AWC DATABASE CATALOG/ATLAS
CORRECTION FORM

Map: Ketchikan B-6, Ketchikan 1:250

Water Body Number: 101-47-10150-2049

Nomination Number: 14-614

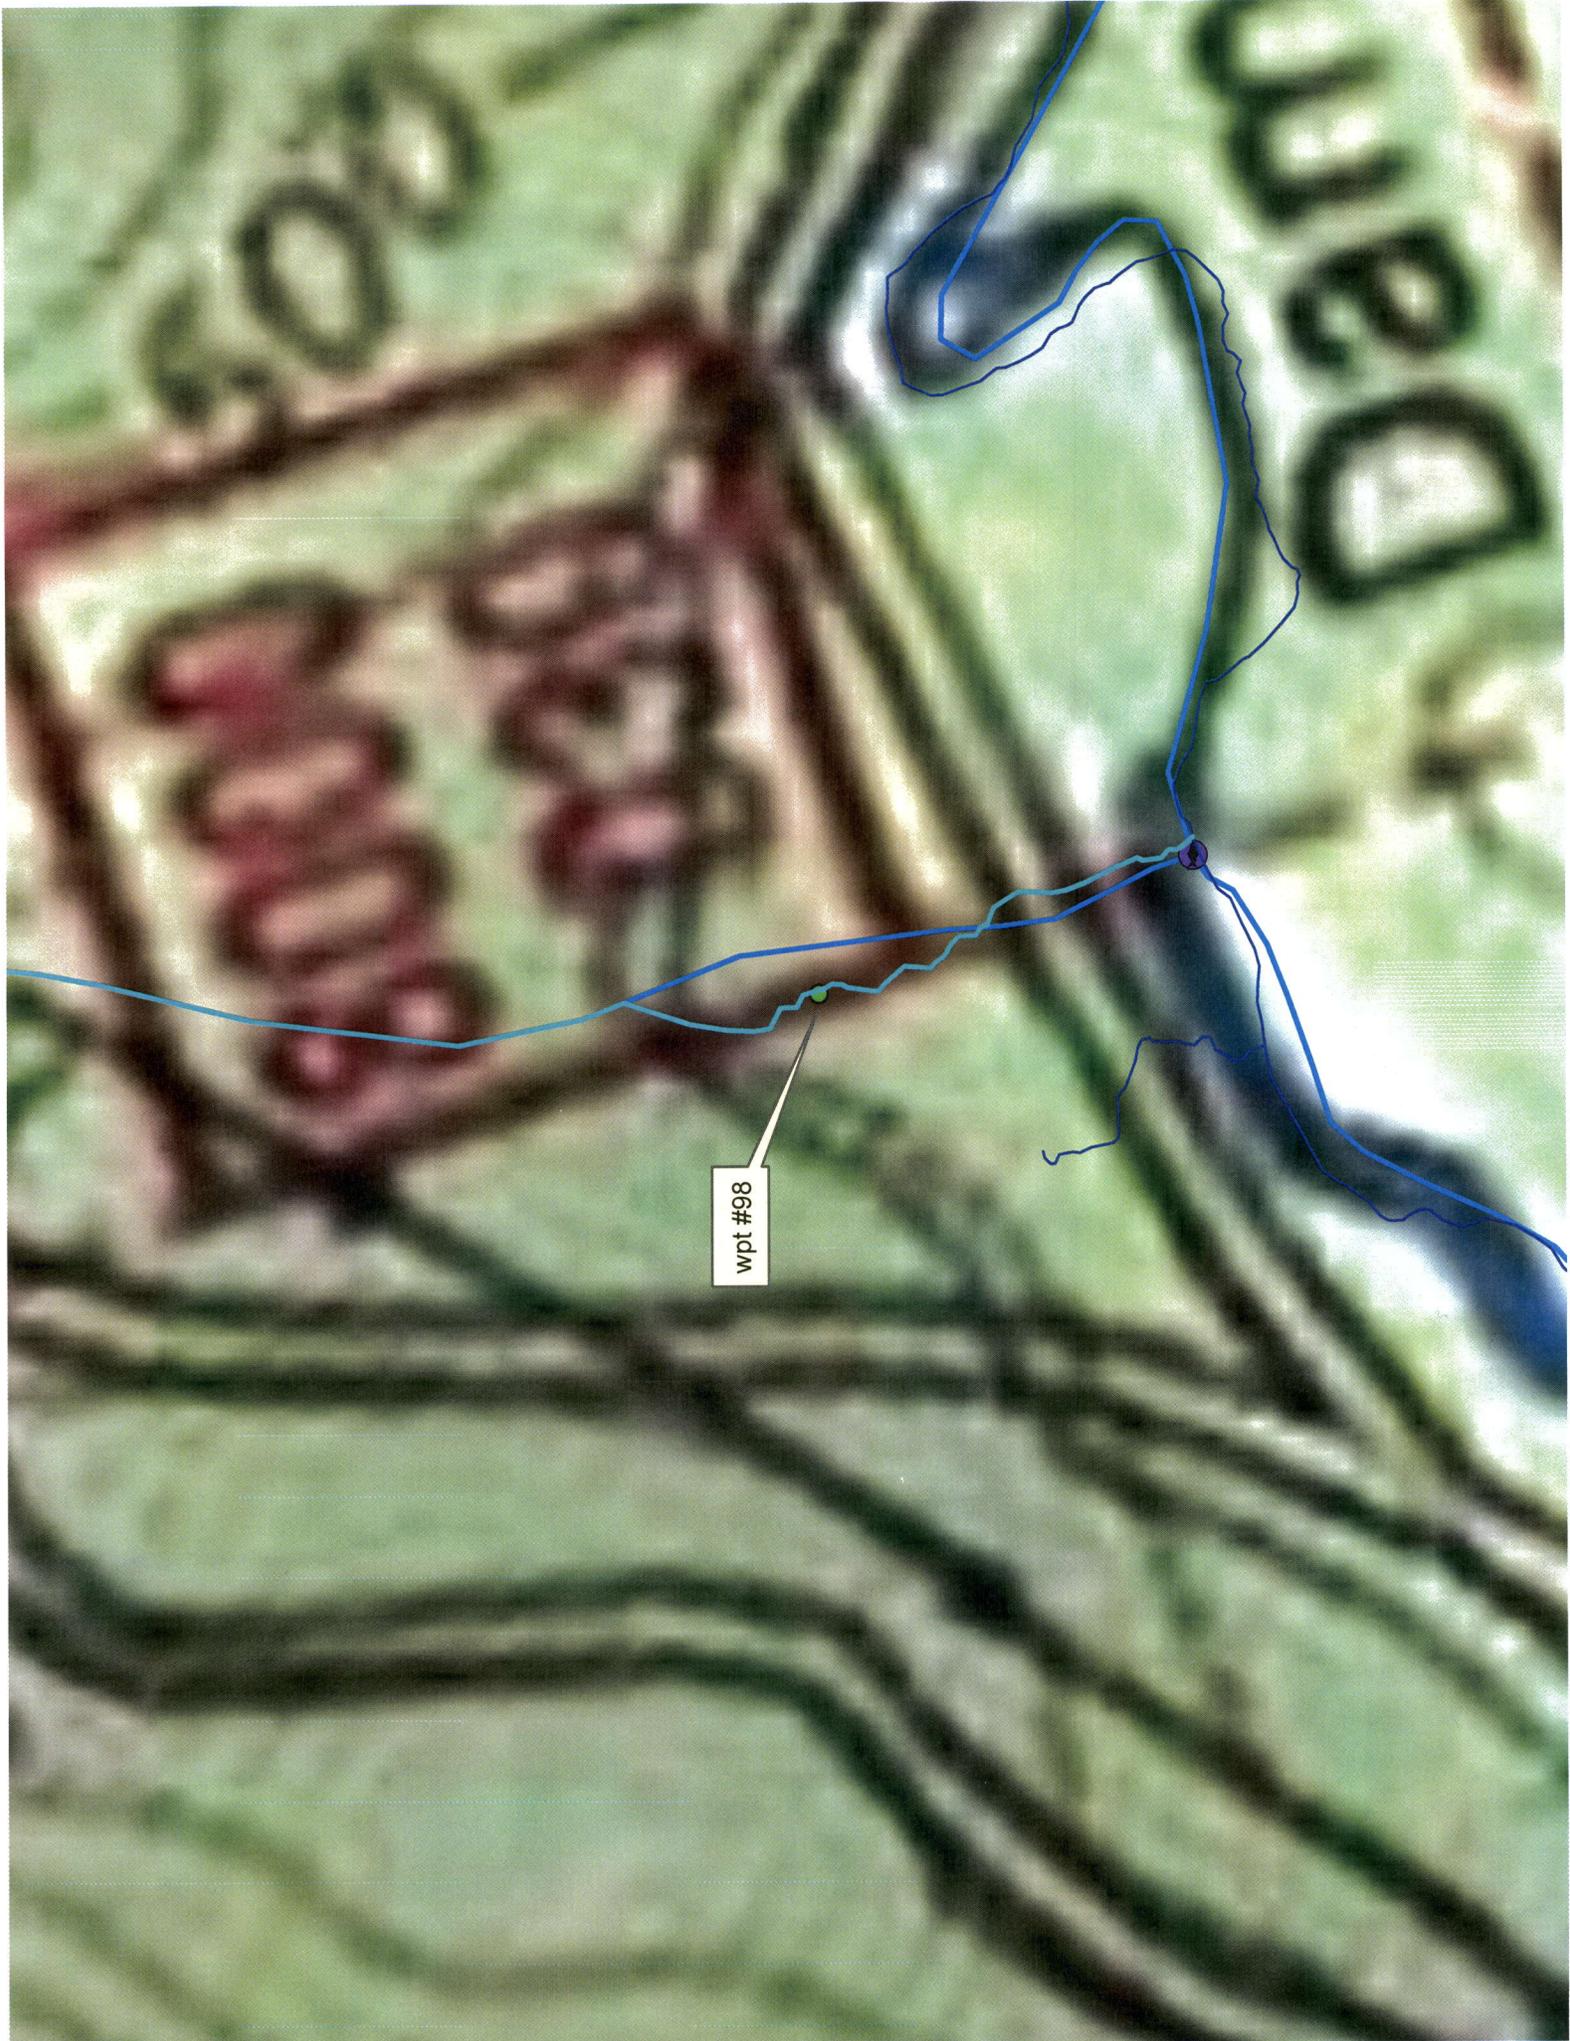
Describe Change(s): end stream @ wpt #98 (55.4352, -131.6795), add barrier,
 reposition current upper pt species downstream to barrier location

wpt #98

Figure 1.- 101-47-10150-2049 Route Correction map.

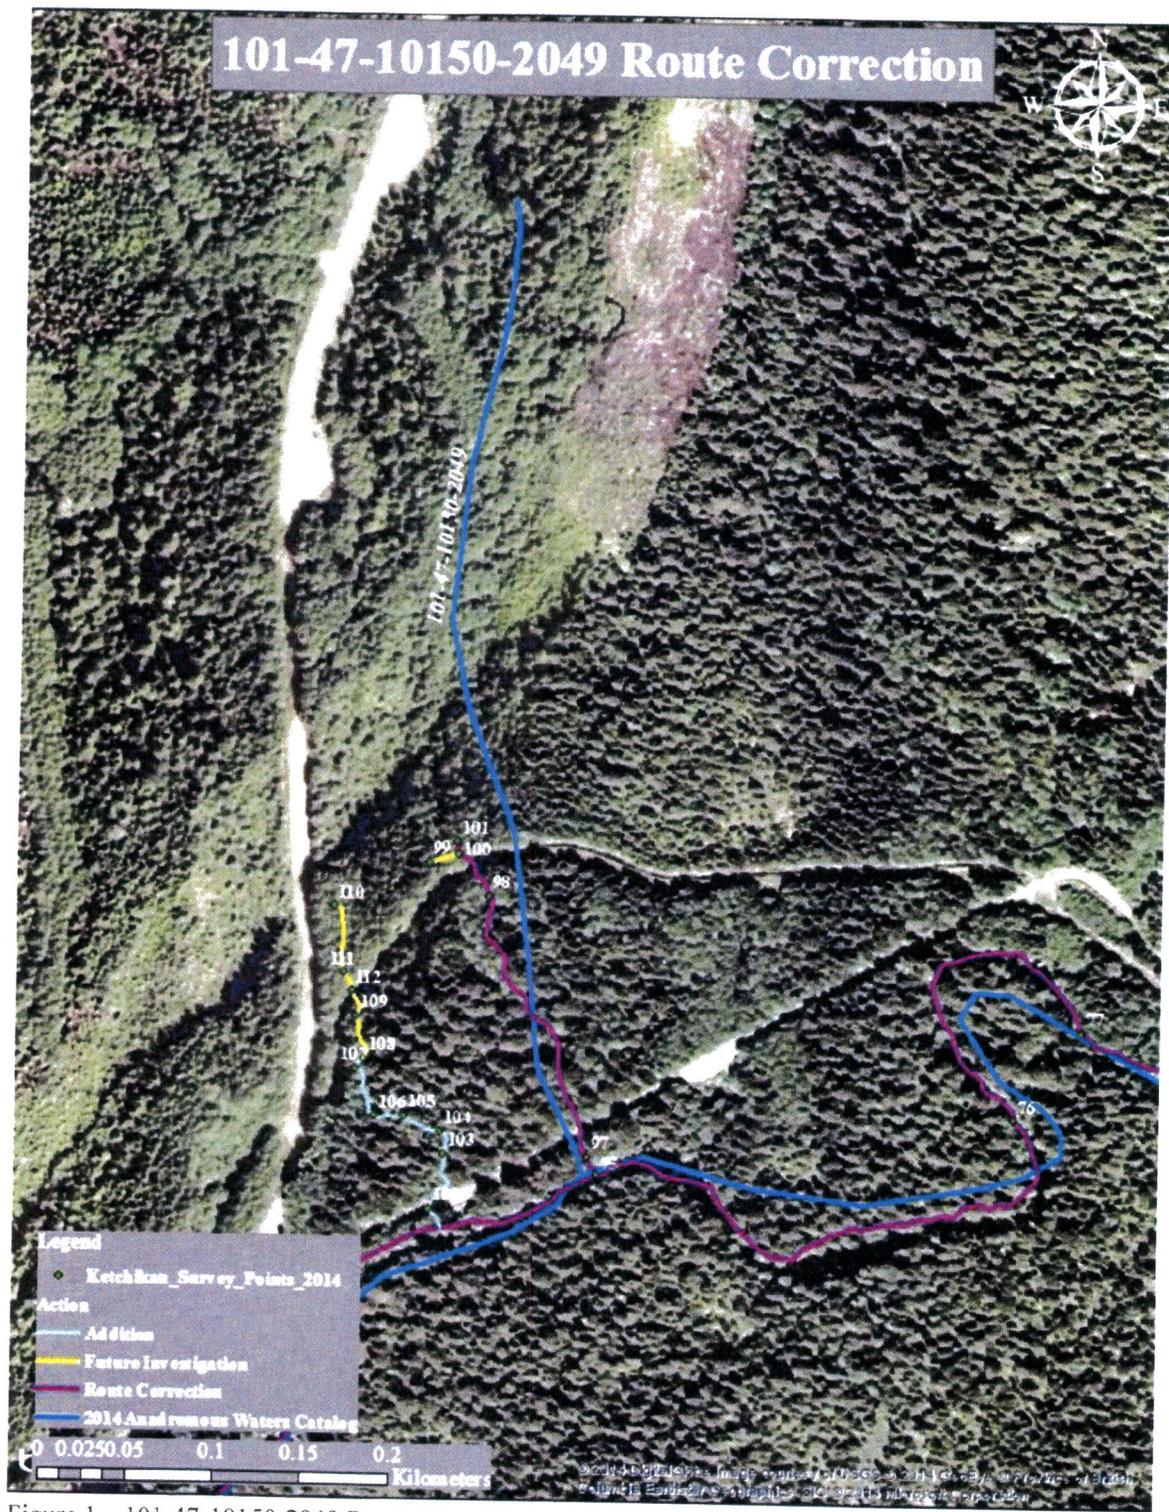
101-47-10150-2049**ROUTE CORRECTION****Water body name:** Unnamed**Survey date:** 5/6/2014**Water body number:** 101-47-10150-2049**Species & Lifestage:** COsr**Watershed:** Carlanna Creek-Frontal Tongass Narrows **MTR:** C074S090E **Quad:** Ketchikan B-6**Findings:** Fish passage on this stream ends at a series of badly mangled culverts. Sampling efforts above the barrier yielded Dolly Varden only.**Recommendations:** Please update the stream course to reflect the field-verified route.

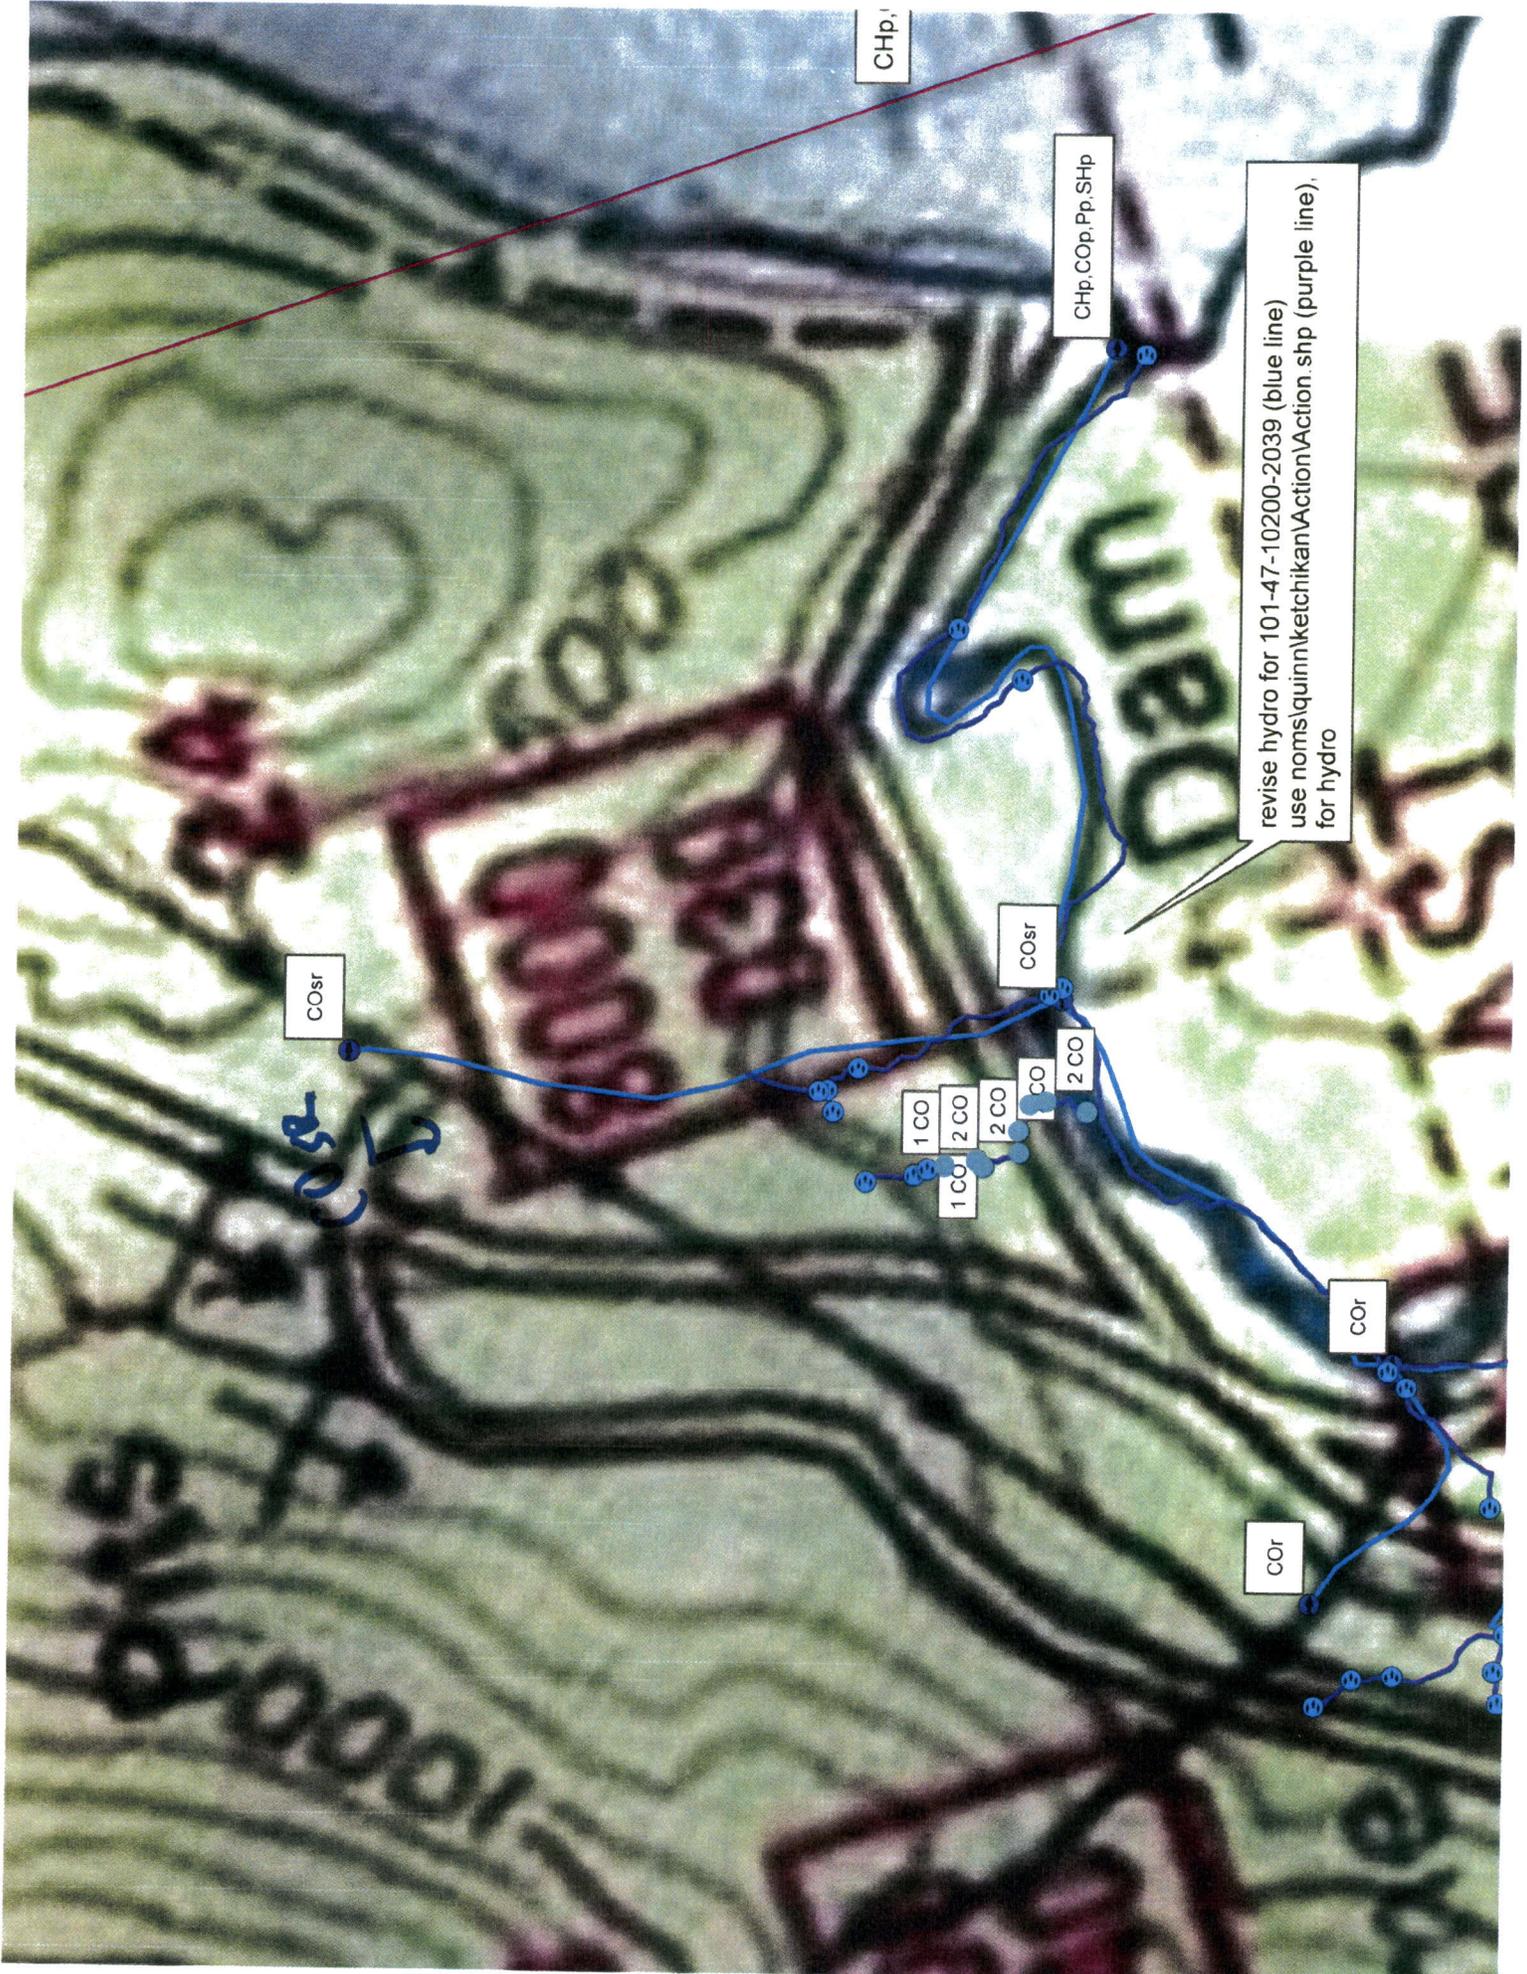
revise hydro for 101-47-10200-2039 (blue line)
use noms\quim\ketchikan\Action\Action.shp (purple line),
for hydro
